Rezoning Transportation Analysis

Petition Number: 2018-151

Revision Log:	Date	Description
	12-20-2018	First Review
	01-23-2019	Second Review
	02-18-2019	Third Review
	05-20-2019	Fourth Review

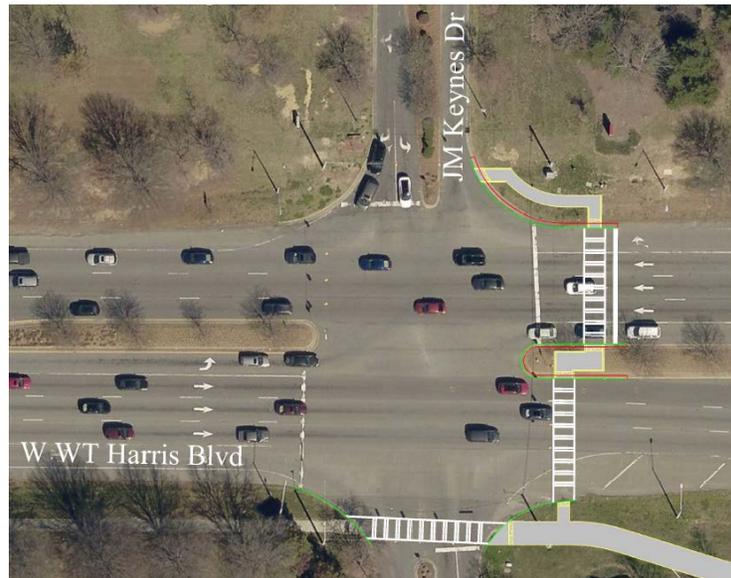
12. **Revised Comment per site plan 5/14/19:** The petitioner should revise the site plan and conditional note(s) to provide complete engineering construction documents submitted to the City for approval/permitting. The petitioner shall implement all geometric improvements, including two (2) accessible ramps, concrete work, signing/pavement improvements, etc. CDOT will be responsible to design and implement all necessary traffic/pedestrian traffic signal modifications ~~-\$80,000 contribution toward the completion-~~ at the proposed "Z" pedestrian crossing at WT Harris Blvd. and JM Keys intersection. See the below conceptual pedestrian improvements at this location.

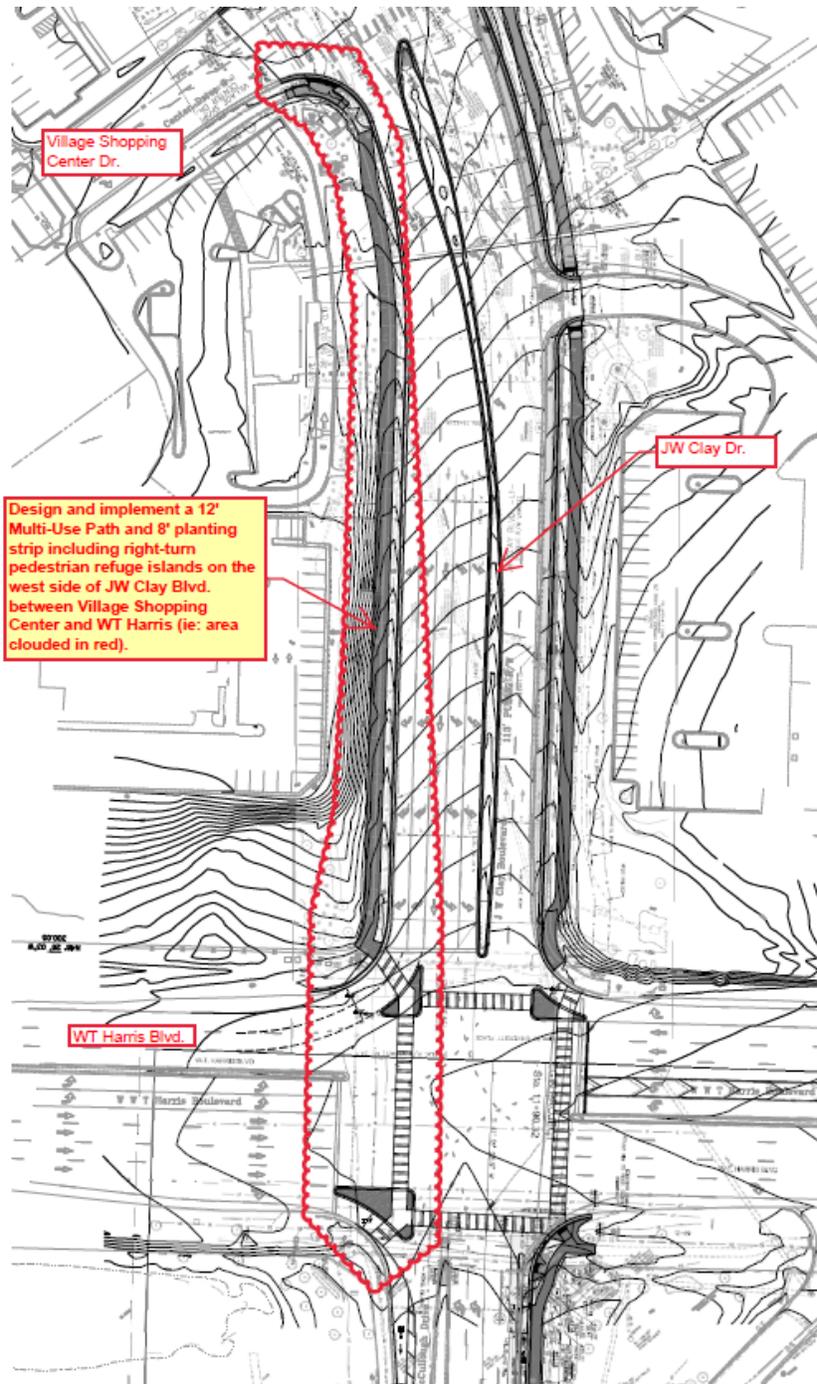
13. ~~New Comment:~~ The petitioner should revise the site plan and conditional note(s) to design and implement streetscape, bike and pedestrian improvements on the west side of JW Clay Rd. between WT Harris Blvd and Village Shopping Center Dr. (see comment 2.A. above and the recommended conceptual improvements for this section of JW Clay Rd. below).
